MONACO
COACH CORPORATION

Re: Recall-Villa International Belt Buckle Mount

Recall Repair Procedures

Recall 04VXXXX Villa Seat Pedestal

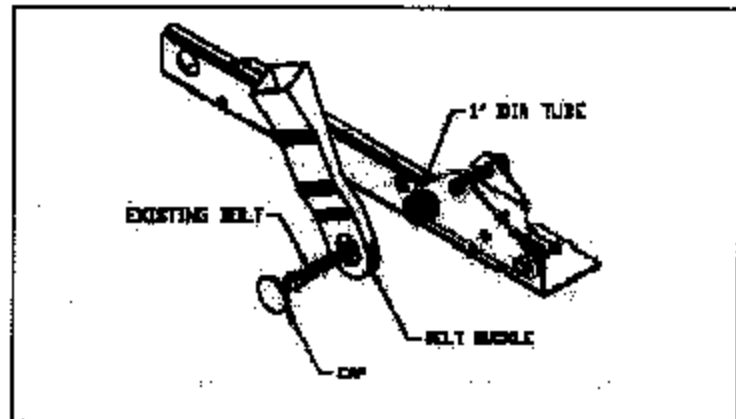
1. Remove cap and loosen existing bolt to remove belt buckle.
